# A47 Wansford to Sutton Dualling

### **Appendix 13.2 – Drainage strategy report**

A47 Wansford to Sutton  
Development Consent Order 202[x]

<b>Regulation Number:</b>	Regulation 5(2)(a)
<b>Planning Inspectorate Scheme Reference</b>	TR010039
<b>Application Document Reference</b>	TR010039/APP/6.3
<b>BIM Document Reference</b>	HE551494-GTY-HDG-000-RP-CD-00001-C01
<b>Author:</b>	A47 Wansford to Sutton Project Team, National Highways

DRAINAGE LAYOUT PLAN  
SHEET 6 OF 7

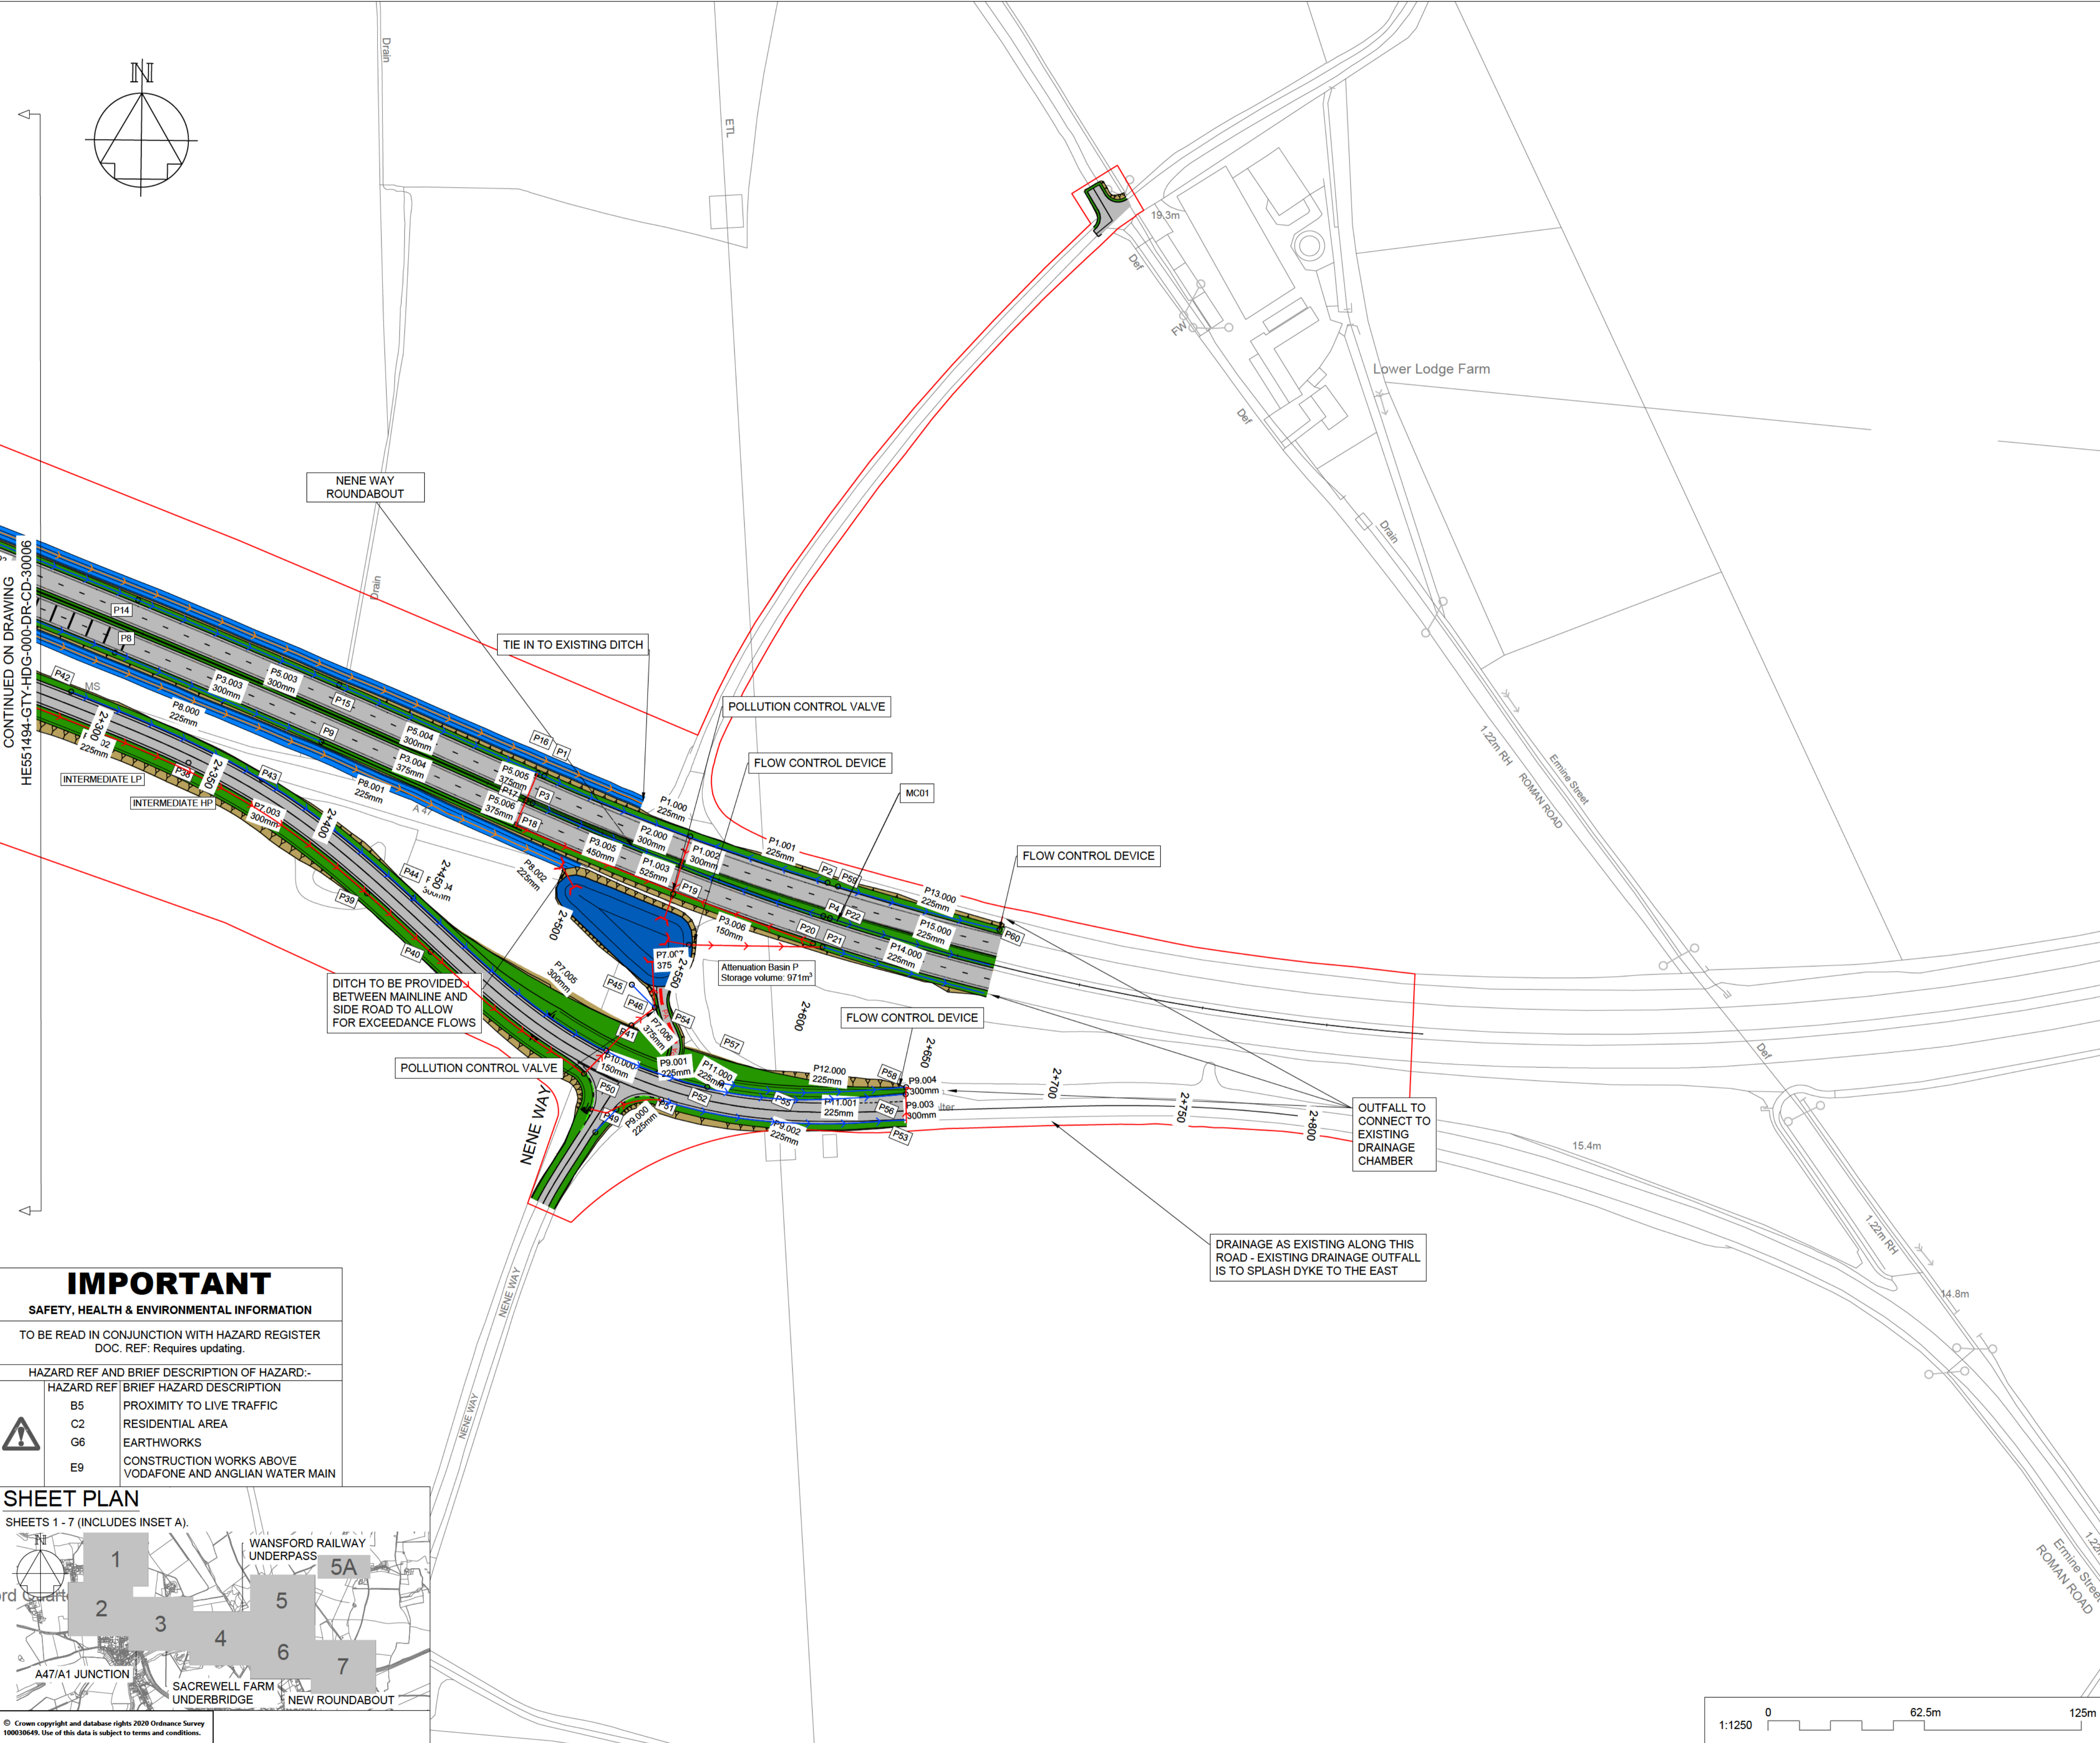
#### Sheet 6

1. Infiltration basin L - ground investigation information and infiltration test results need to be provided, which should also include the levels of the water table.
2. In relation to the proposed new road north of the roundabout and the associated culvert, if these were intended to be offered for adoption to the Local Highways Authority, then we would recommend that you get in touch with the PCC's Highway Control team regarding this.
3. Network P - we note the drawing references a connection into S11 or to continue along side road, as such we require clarification of what this refers to.
